CITY COUNCIL MEETING STAFF REPORT

DATE OF MEETING:	June 4, 2024
NAME OF PROJECT:	The Homestead Resort
NAME OF APPLICANT:	The Homestead Group, LLC
AUTHORIZED REPRESENTATIVE:	Berg Engineering
AGENDA ITEM:	The Homestead Phases 1 & 2
LOCATION OF ITEM:	700 North Homestead Drive
ZONING DESIGNATION:	RZ

Subject: Homestead Resort, Preliminary Approval Review

Homestead Phases 1 & 2 Preliminary Approval

2024 MASTER PLAN

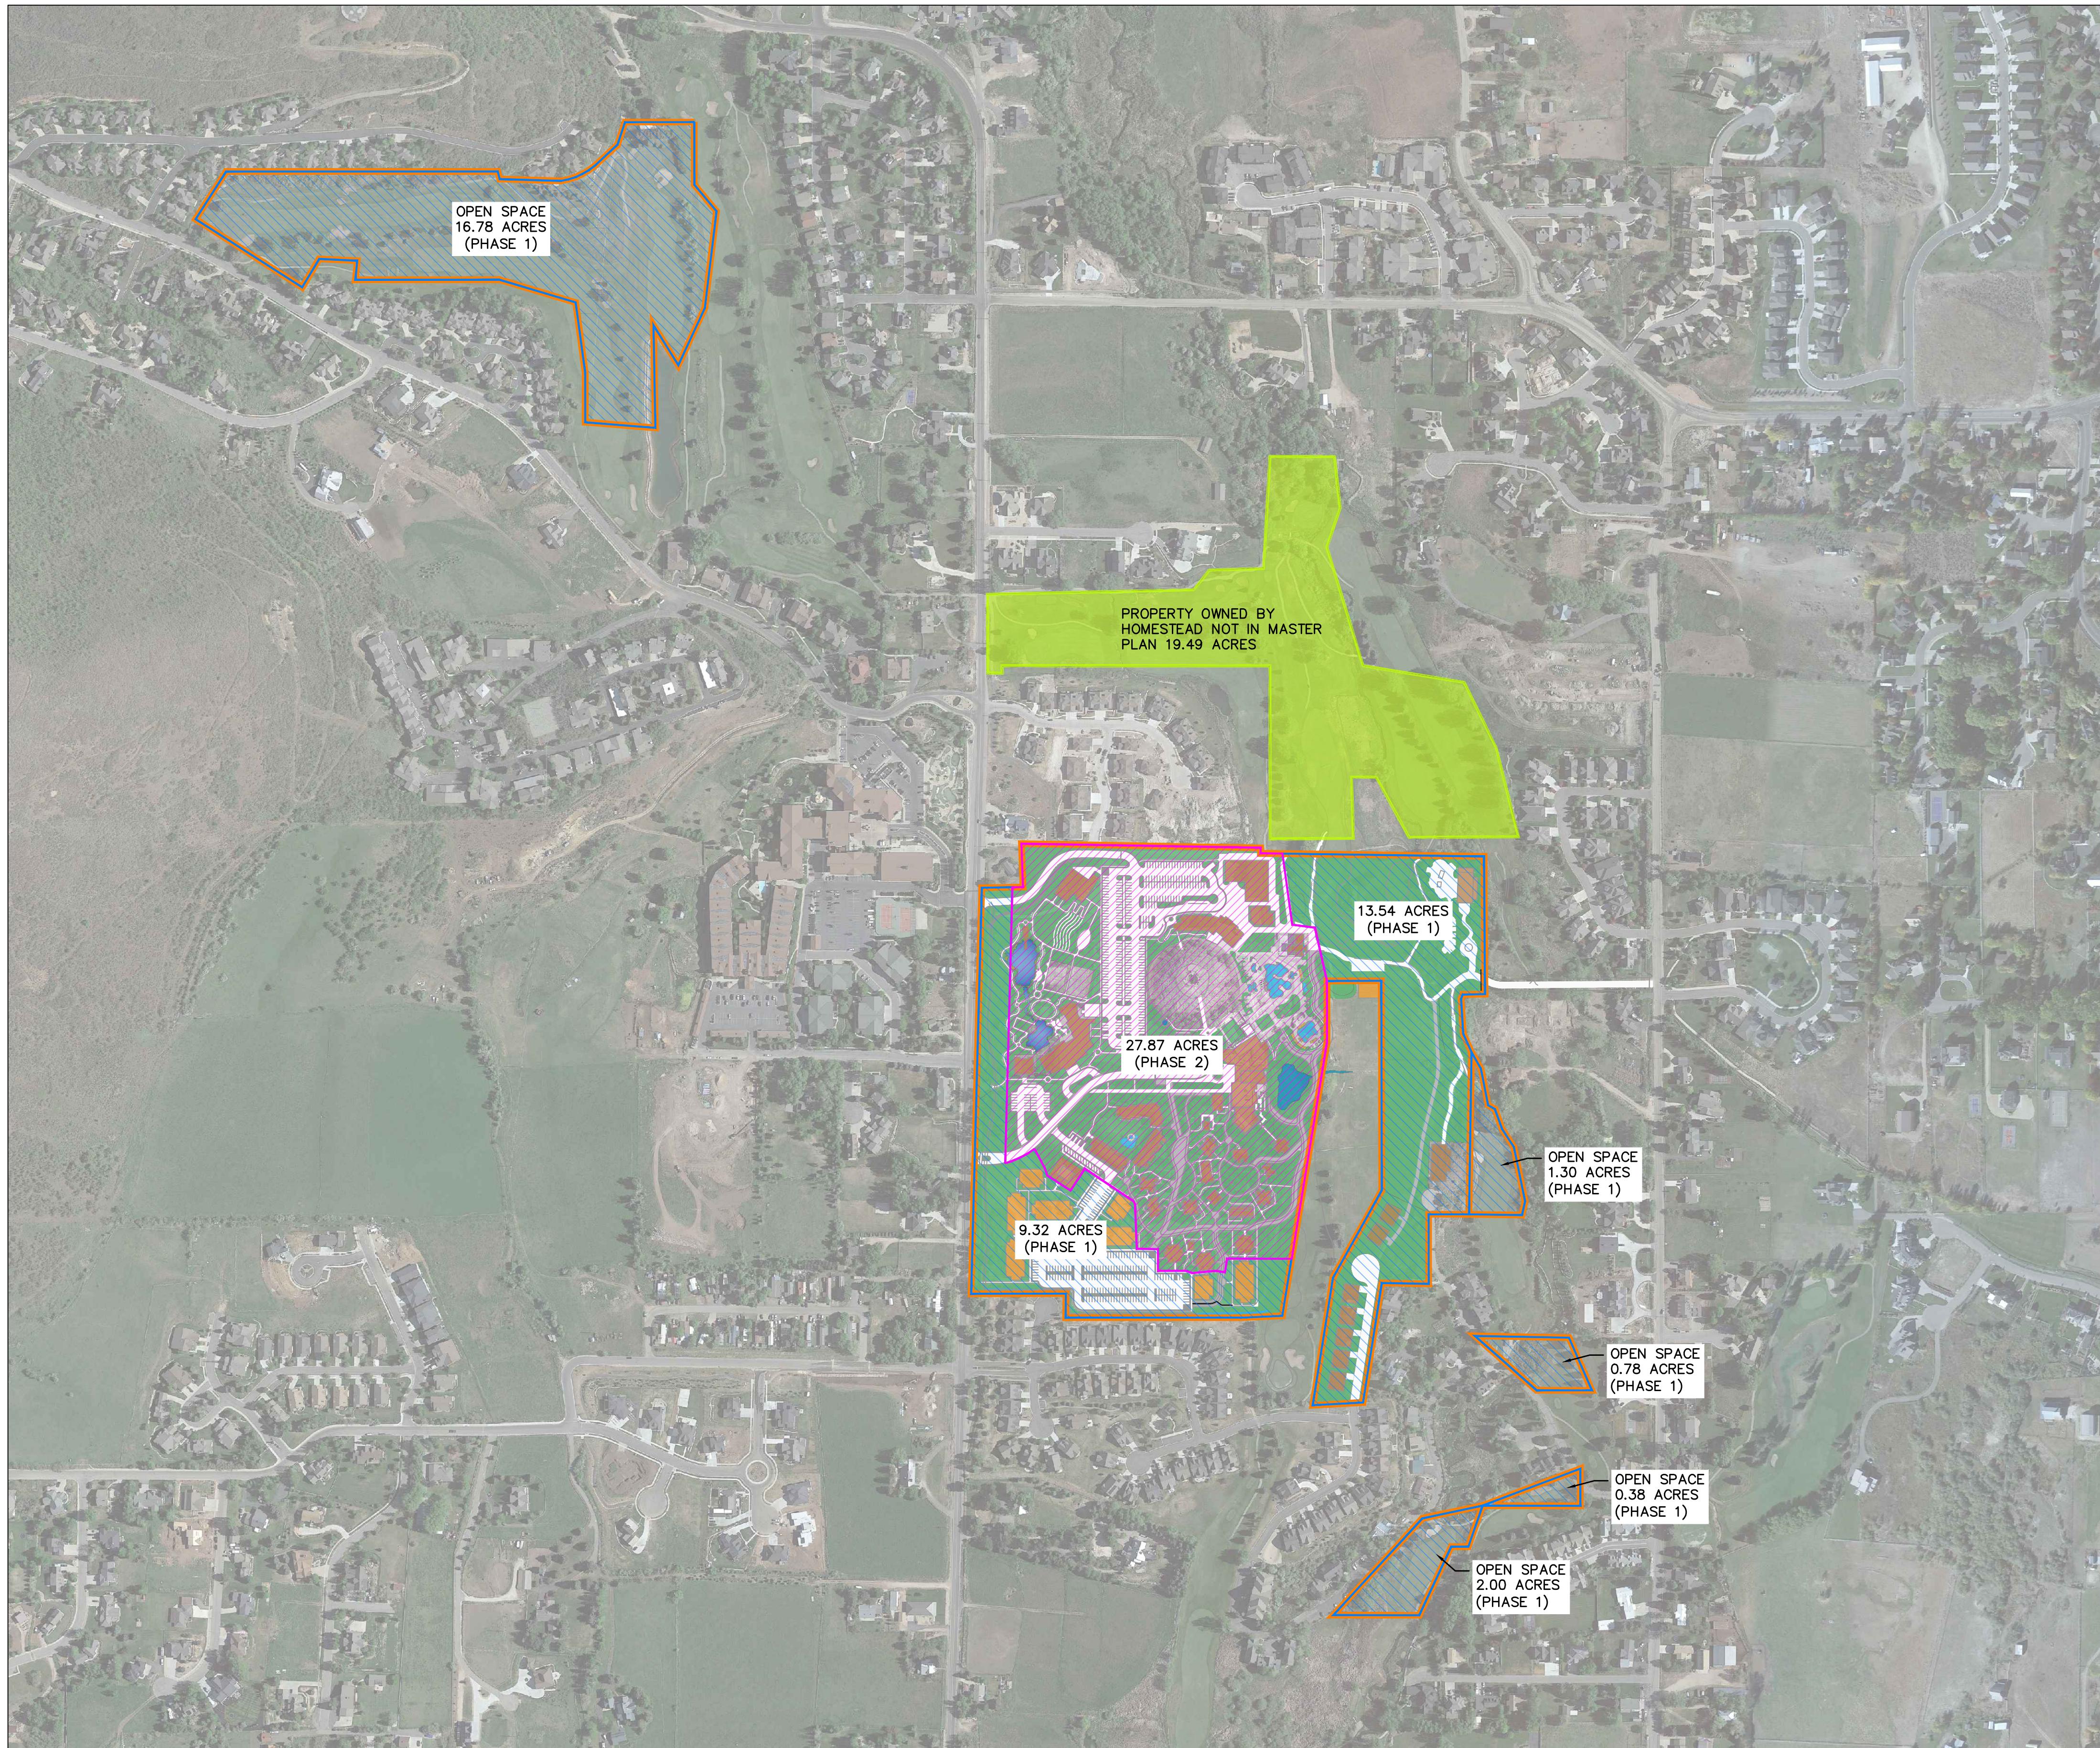
- The proposed plans show the main entrance to the Homestead Resort being relocated to the south.
- The traffic study completed by Hales Engineering shows four points of access to the resort. The two main access points are off Homestead Drive. The existing North access and the proposed re-located South access. A small percentage of traffic is proposed to access the resort through the Links development using St Andrews Drive and through Mountain Springs using Mountain Springs Drive. The traffic study is showing no access off Pine Canyon Road near 720 North, at the existing maintenance entrance.

- To maintain an acceptable level of service on Homestead Drive, the traffic study is recommending a Southbound left-turn pocket and a North-bound right-turn pocket be installed on Homestead Drive at both the North and South entrance.

WATER PLAN

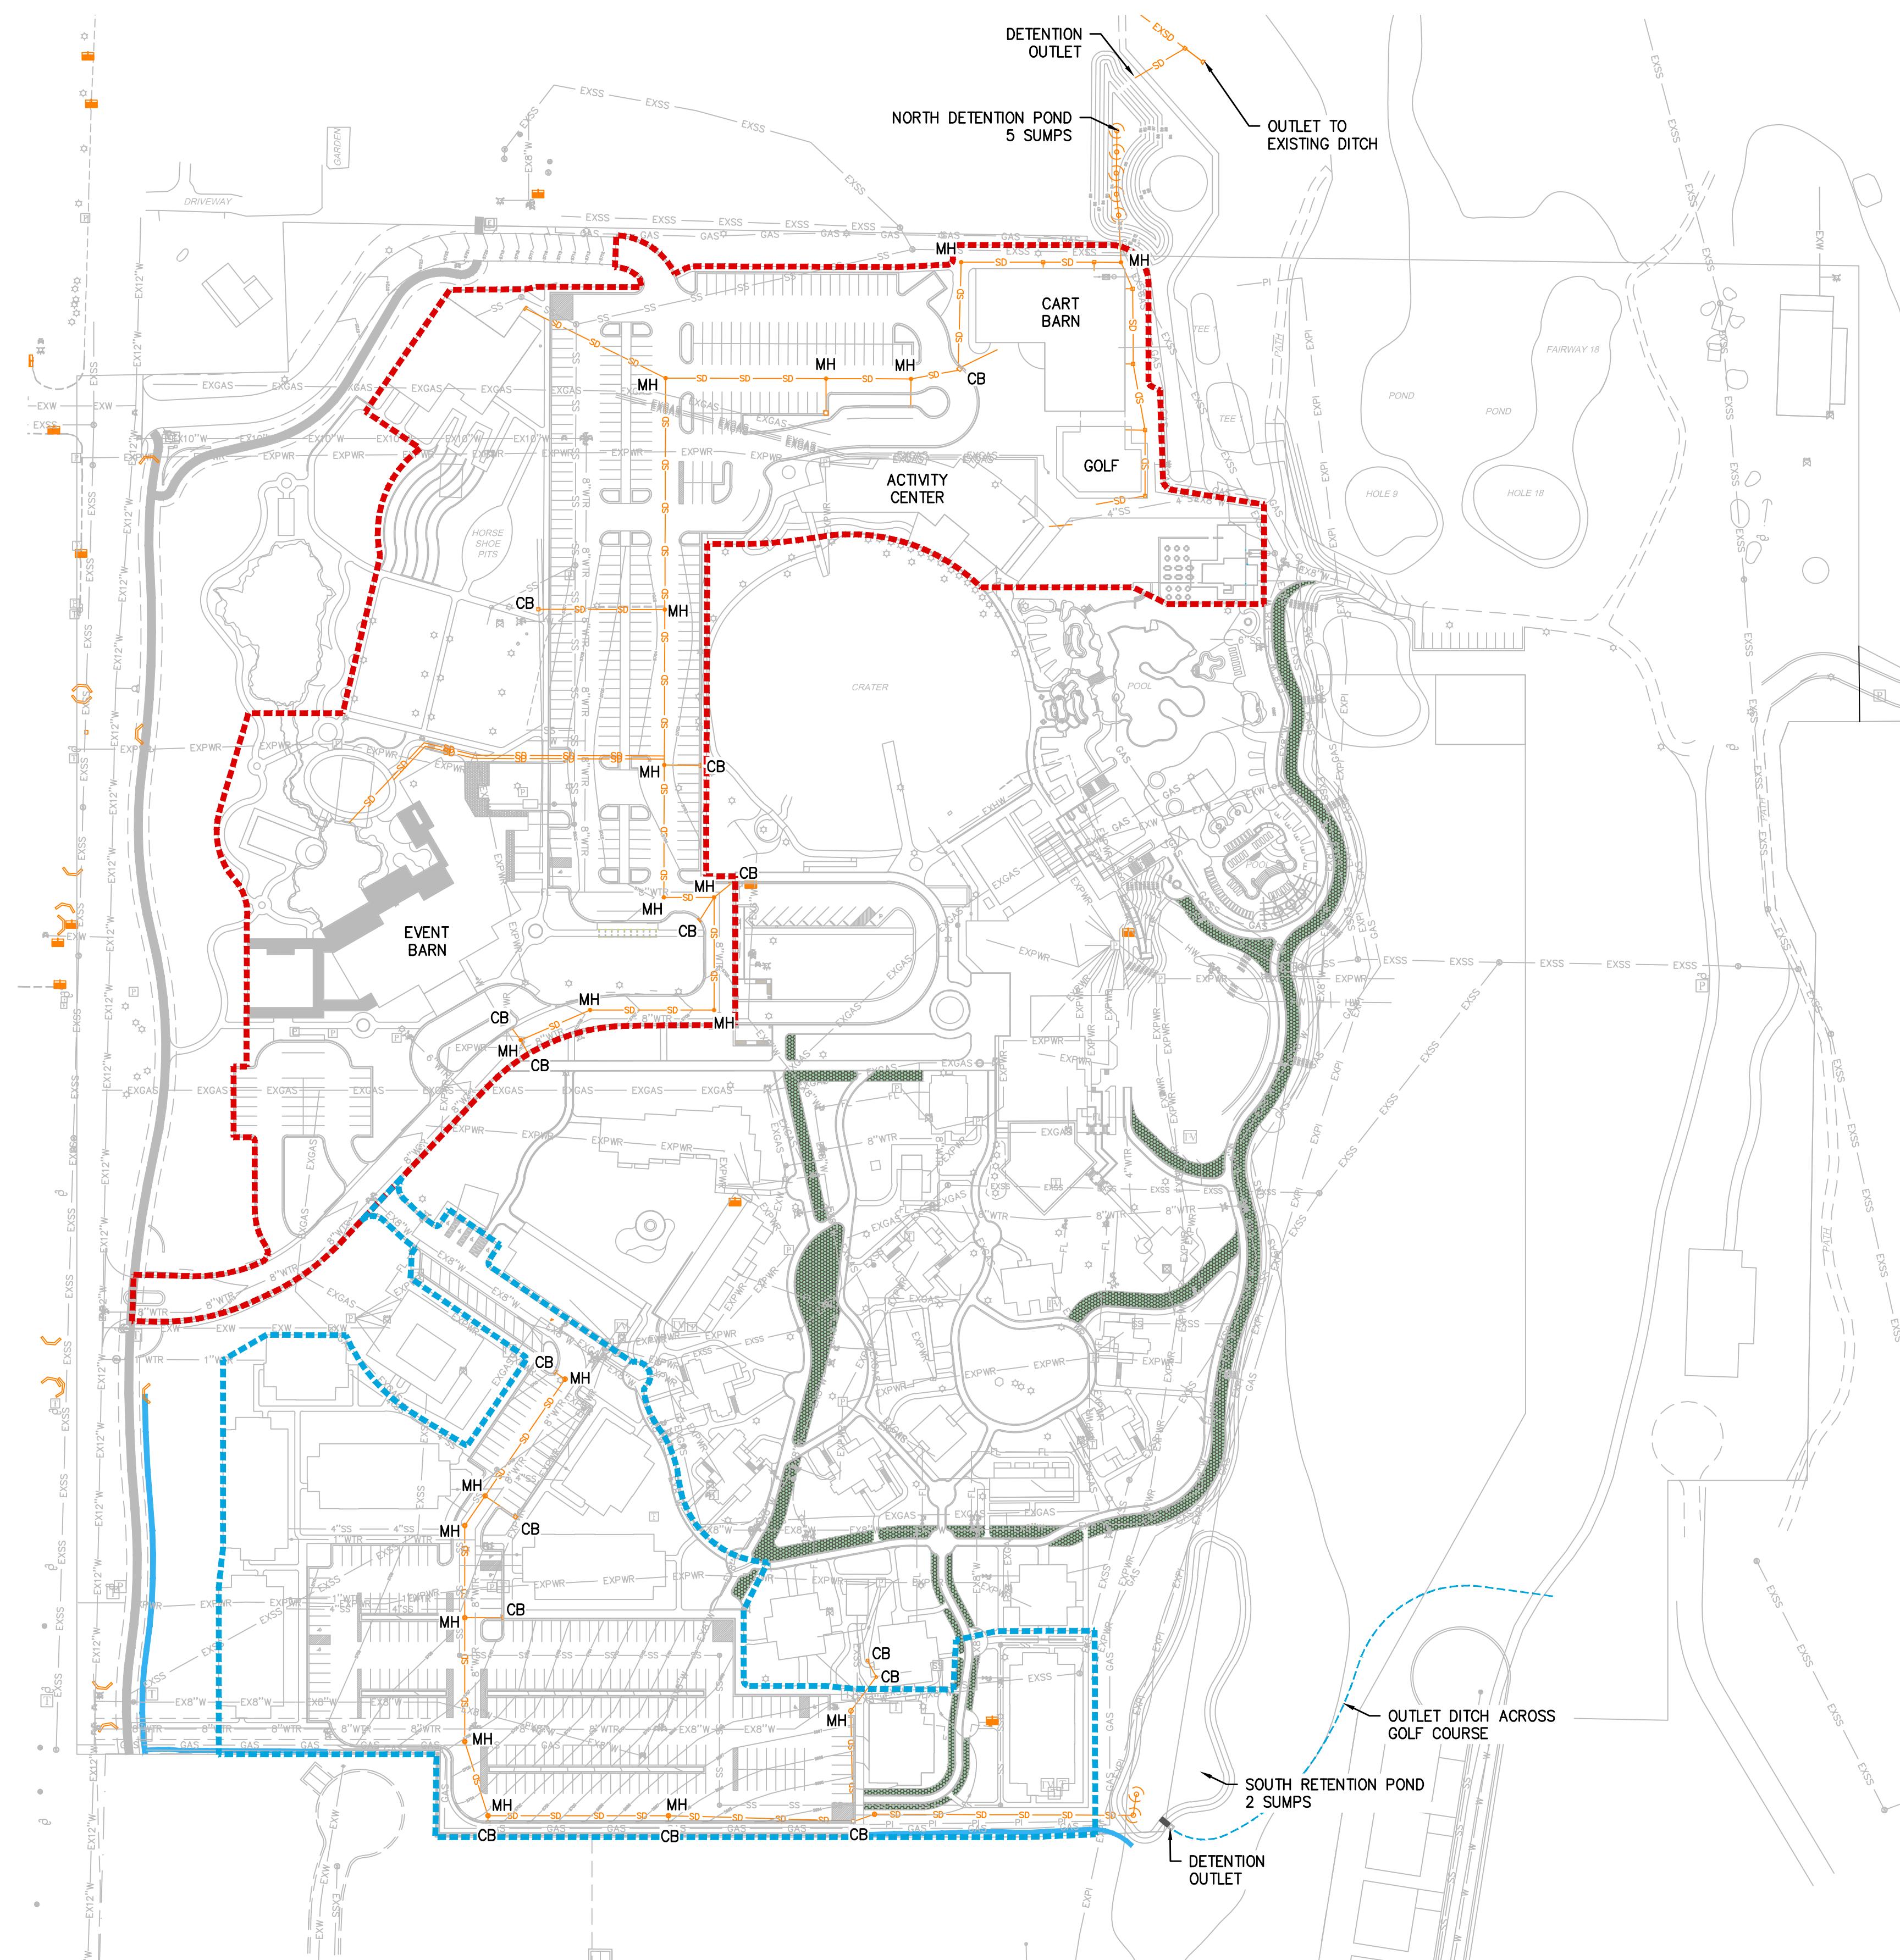
- Each of the proposed phases within the Resort will be served from the Cottages on the Green pressure zone. This is the higher pressure zone within the City.
- To ensure adequate fire flow the waterlines diameters, looped connections, and previously replaced water lines will need to be analyzed and established prior to Final approval.
- The location of each culinary water meters should be shown on the plans. Each building should have an individual culinary water meter.
